May 28, 1981

Re: TFN 1 2/188, APS R&D License Application

Arizona Public Service Company (APS) and Nuclear Assurance Corporation (NAC) have carefully reviewed letters received from Mr. Patrick H. Boles dated September 9 and 15, 1980 which provide review comments on the above referenced application. Through discussions with Land Quality Division personnel and careful in-house evaluation, APS-NAC have prepared answers to your comments and questions. Where an answer required the revision of the text or an illustration in the application, replacement pages containing the response have been provided. When no change in the application was determined to be necessary, our response is summarized, herein.

FIGURE 4.8
WELL PATTERN LAYOUT
AND GENERALIZED
FLUID FLOW PATHS

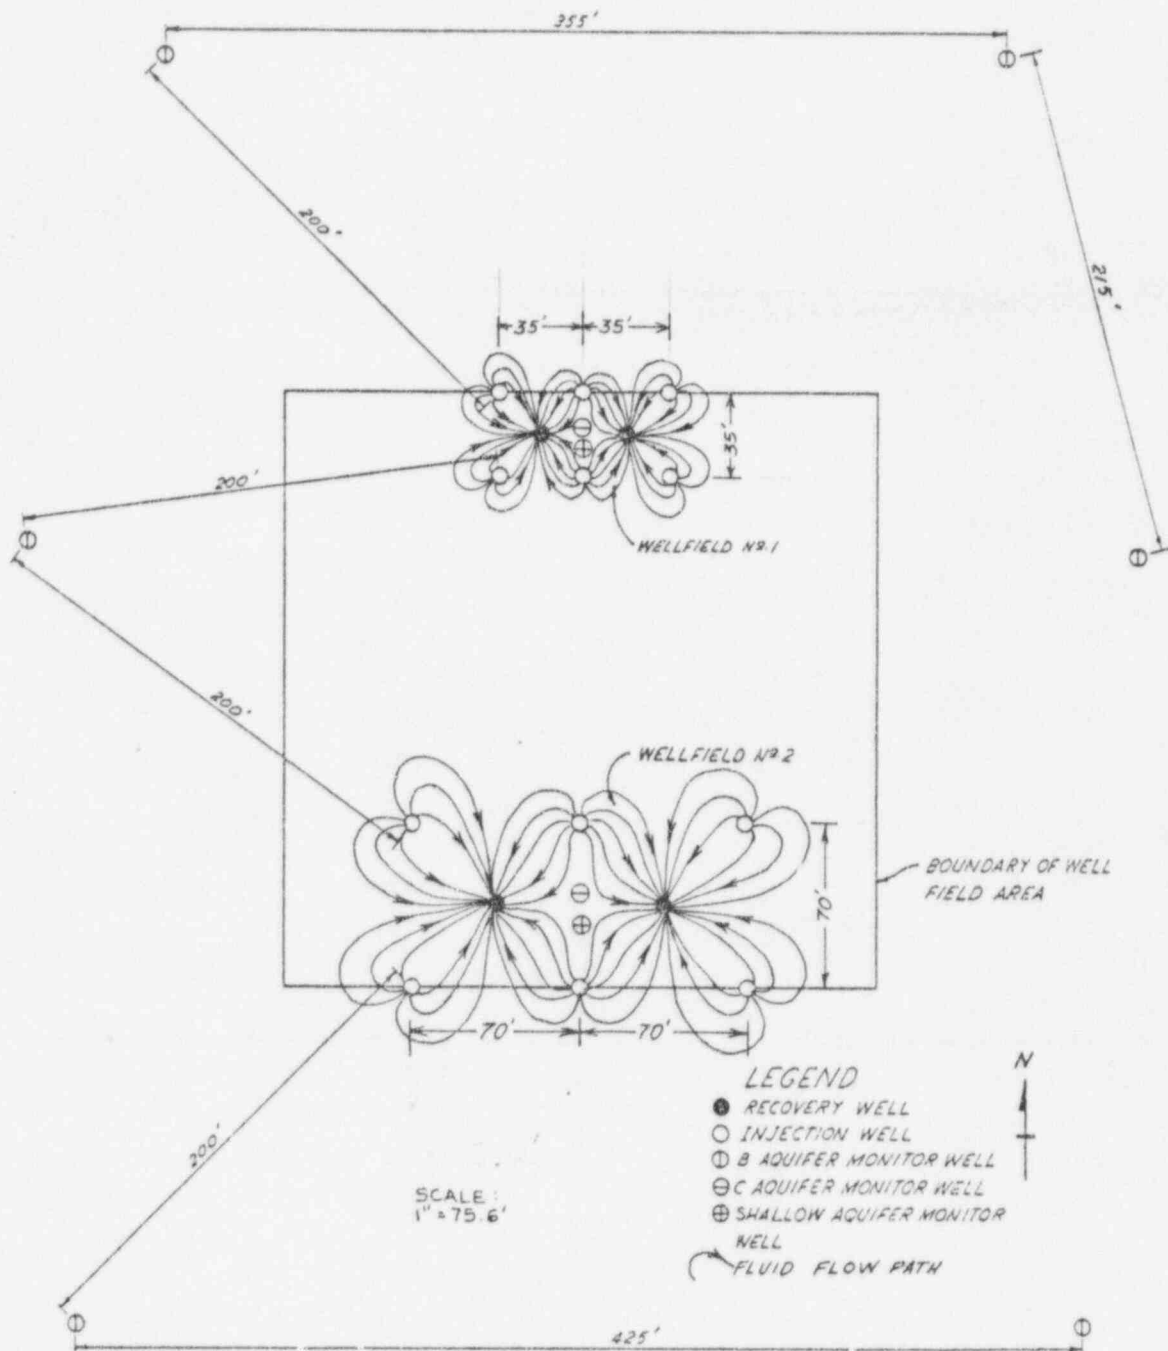
Generalized fluid flow paths have been shown on Figure 4.8.

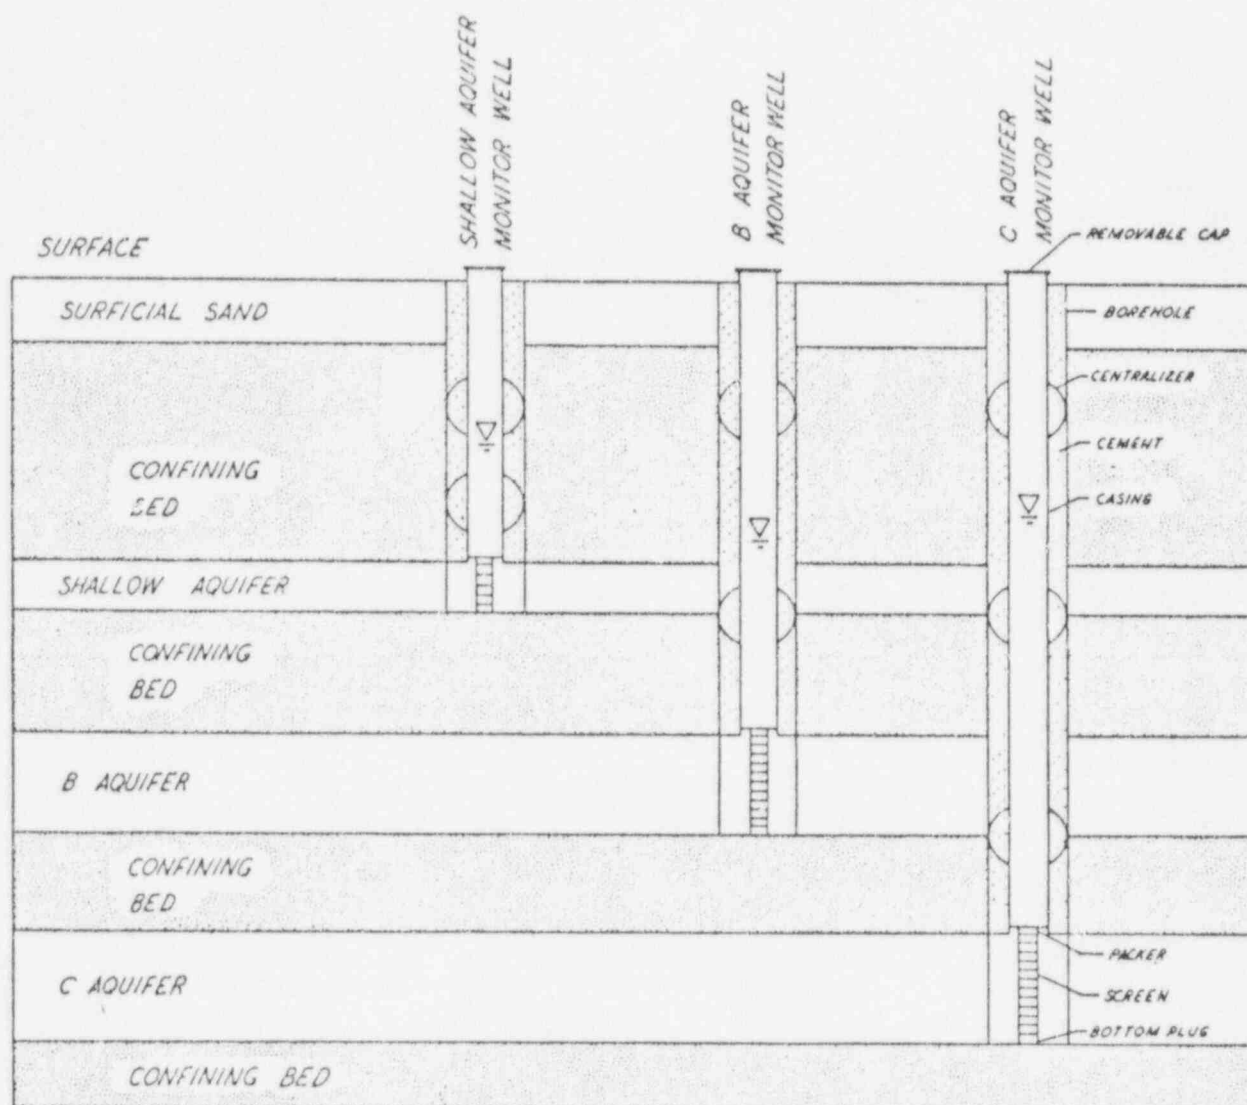
- (1) It has been indicated in the application on page 4-28 that monitor wells will be constructed by either Method No. 2 or Method No. 3 proposed in the application. A generalized schematic of monitor well design is shown by Figure 4.9.
- (2) The application has been revised on page 4-30 and Figure 4.8.
- (3) The application has been revised on Figure 4.9.

FIGURE NO.
4.4

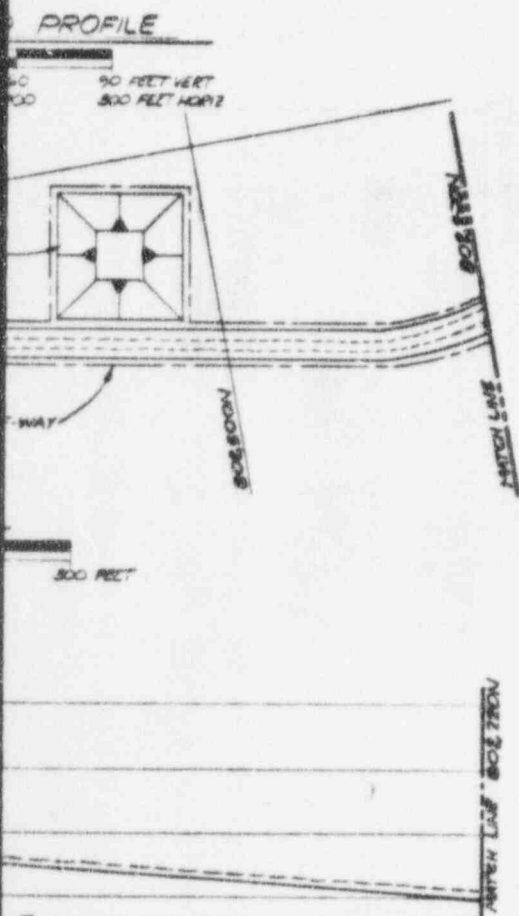
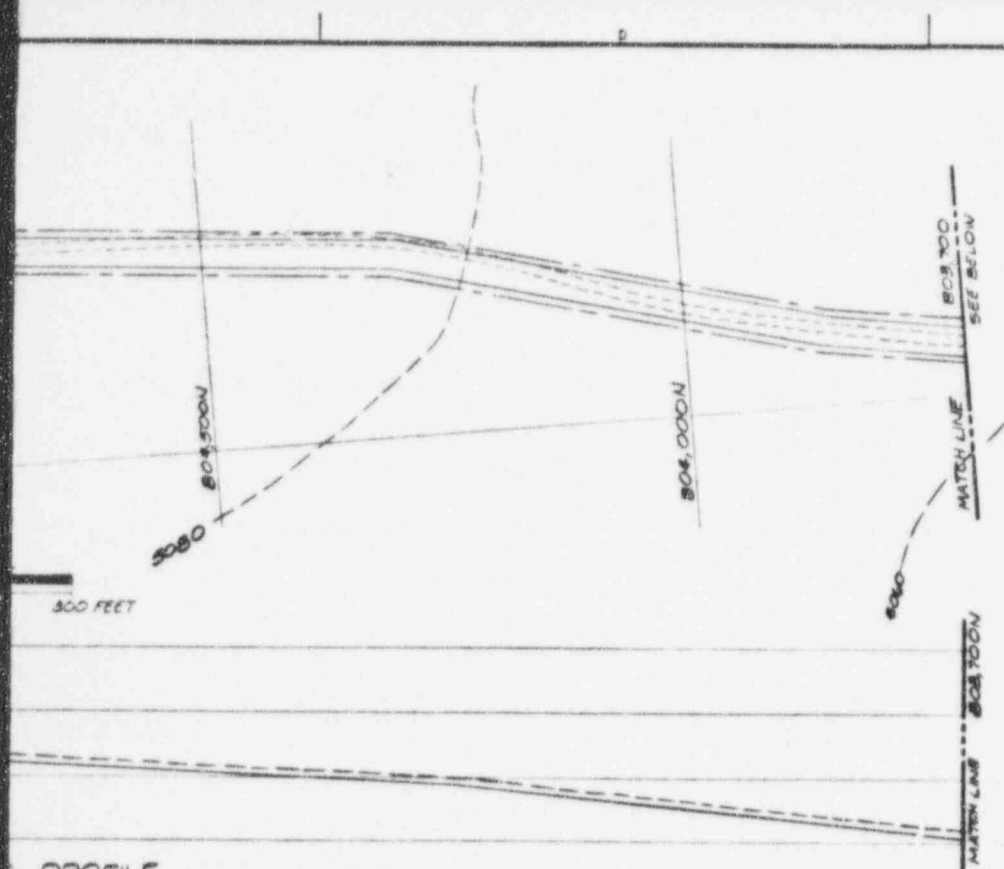
- (2) Figures 4.3, 4.4 and 4.5 have been revised to indicate three topsoil stockpiles located on flat terrain immediately adjacent to the access road. The stockpiles have been positioned for economical manipulation of topsoil.
- (3) The upper 60 inches of topsoil will not be used for berm construction as indicated in revisions on pages 4-18 and 4-18a.

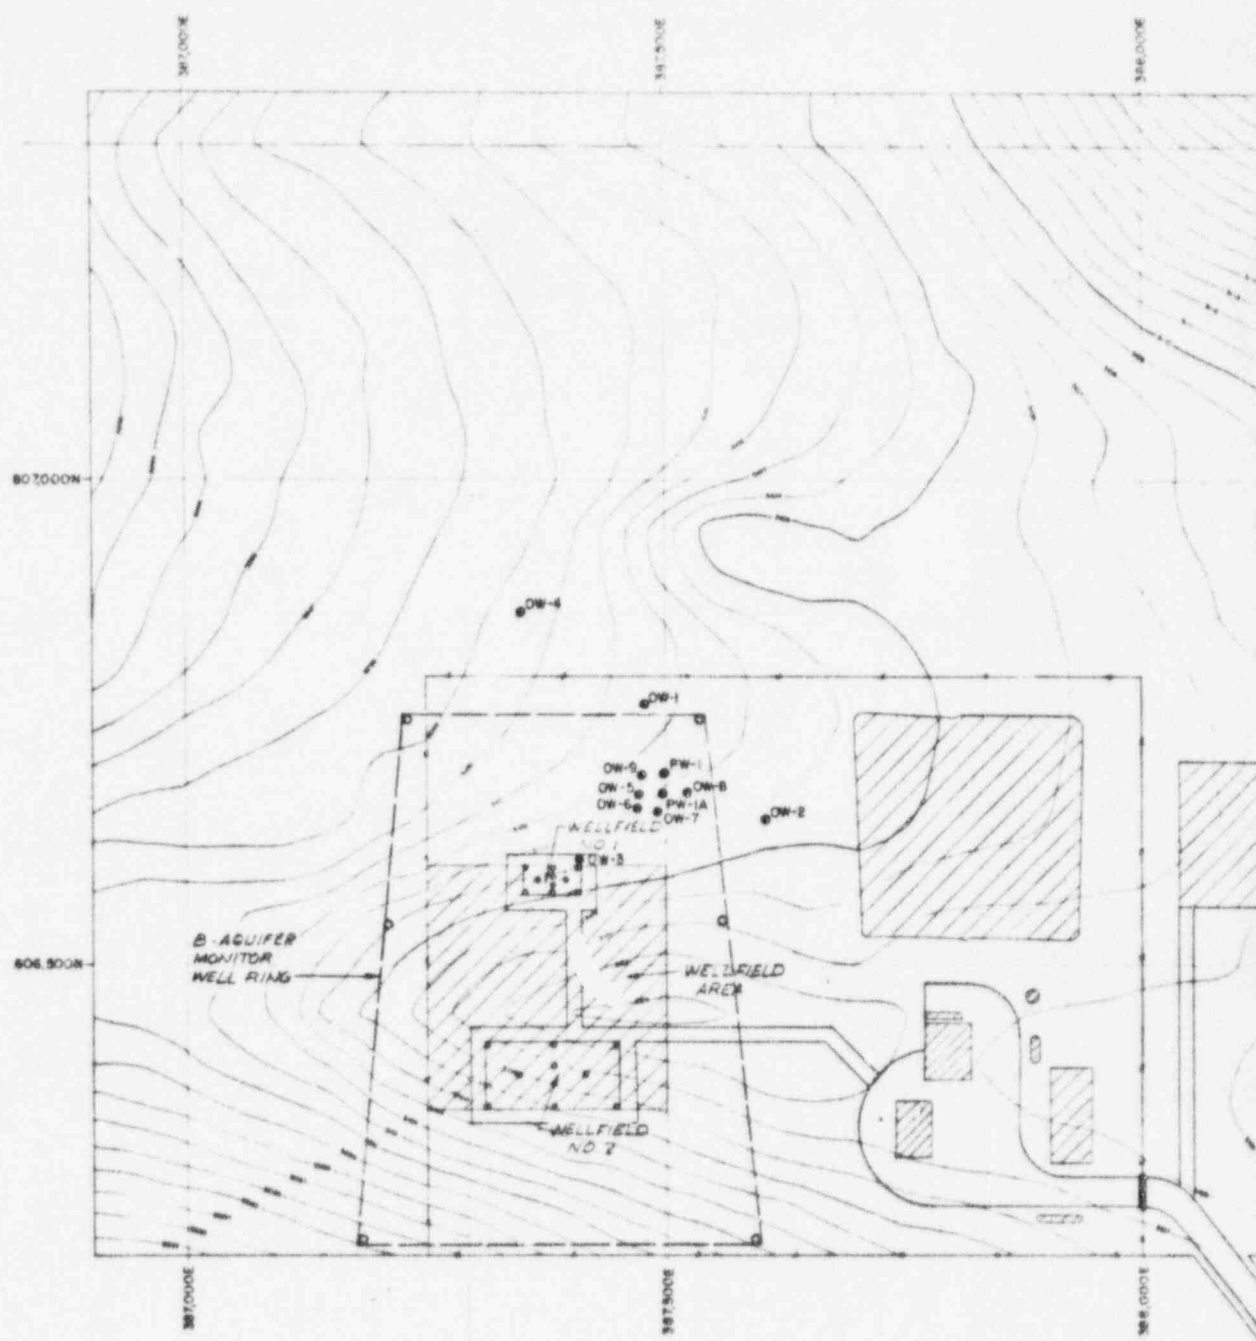
E. Figure 4.7 has been revised.
